Proposed Milton Quarry East Extension
JART COMMENT SUMMARY TABLE – Ecological Enhancement Plan

JART Comments (December, 2022)	Reference	Source of Comment	Applicant Response (January 2023)	JART Response
Report/Date: Ecological Enhancement Plan (EEP) & Rehabilitation Plan Report December 2021			Author: Goodban Ecological Consulting Inc.

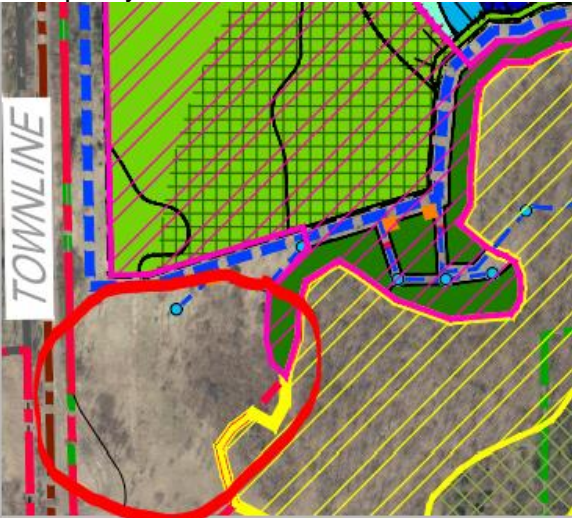
6.	<p>Figure 8. Combined Ecological Enhancement Plan (EEP) and MQEE Rehabilitation Plan: Regarding the CUM1-1c vegetation community (ELC unit, circled in red in figure below) located within the Southwest corner, given the lag time of potential future uses, CH recommends the opportunity for reforestation enhancement and the improvement of that quality and function of habitat.</p>  <p>NEC would also support seeing enhanced reforestation efforts in this area, in order to improve any remaining east-west linkages to the cox tract given removal of Woodland A. This would address the NEP objectives and policies respecting enhancing natural heritage features and functions.</p>	Ecological Enhancement Plan and Rehabilitation Plan Report	<p>CH</p> <p>NEC</p>	The EEP has been designed to provide net ecological enhancement for key natural heritage features proposed to be removed. Overall, the EEP provides a significant enhancement in overall forest cover compared to existing conditions and reforestation of this area was not deemed necessary to meet the policy requirements of the NEP. Furthermore, this area is part of the lands proposed to be conveyed to Conservation Halton and this area in the future could serve as a strategic area for a small parking area, trailhead etc.
